AREA TO BMPs PROPOSED INLET PROTECTION PROPOSED TEMPORARY INLET SEAL DISCHARGE POINT **NOTES** REVISED PER MCCD REVIEW LETTER DATED 03/25/2025 01 04/11/2025 REVISED PER MCCD REVIEW LETTER DATED 03/25/2025 **CONSTRUCTION PLANS UPPER POTTSGROVE MUNICIPAL COMPLEX** 2290 GILBERTSVILLE ROAD

CONSTRUCTION PLANS UPPER POTTSGROVE MUNICIPAL COMPLEX

REVISED PER MCCD REVIEW LETTER DATED 03/25/2025 01 | 04/11/2025 | REVISED PER MCCD REVIEW LETTER DATED 03/25/2025 NO. DATE

ROCK FILTER OUTLET DETAIL

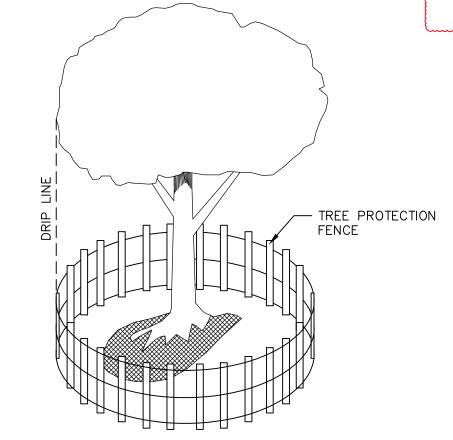
ROCK FILTER OUTLET DETAIL REVISED.

BMP #2 M.R. BIORETENTION AREA

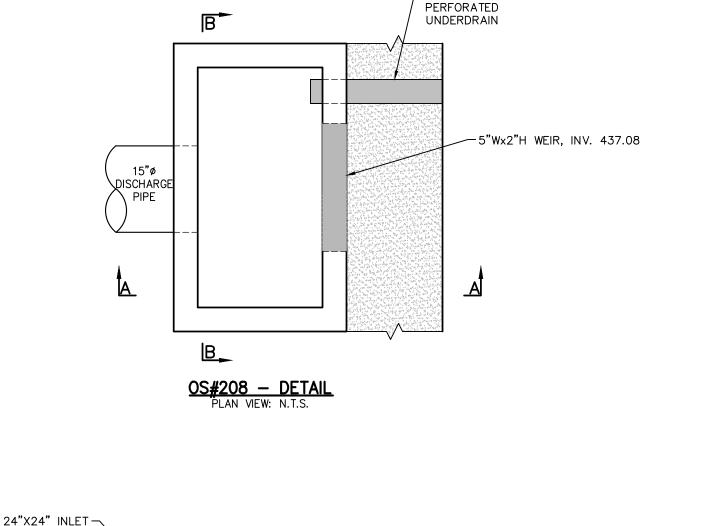
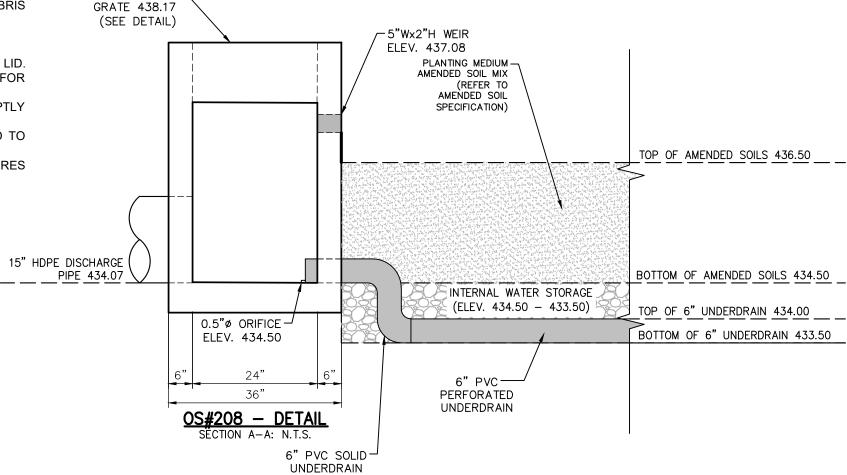
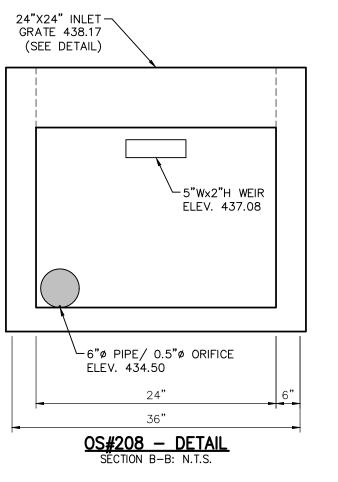
PROFESSIONAL SEAL ADDED TO PLAN. BMP #1 DETAIL REVISED TO INCLUDE UNDERDRAIN, STONE, GEOTEXTILE FABRIC, AND CLEANOUT.

- OS#208 POND LINER OMITTED. BMP #1 BIORETENTION AREA DETAIL- DISCHARGE PIPE INVERT ELEVATION REVISED. BMP #1 BIORETENTION AREA DETAIL— UNDER DRAIN
- INVERT ELEVATION ADDED. CONSTRUCTION SEQUENCING NOTE REVISED.
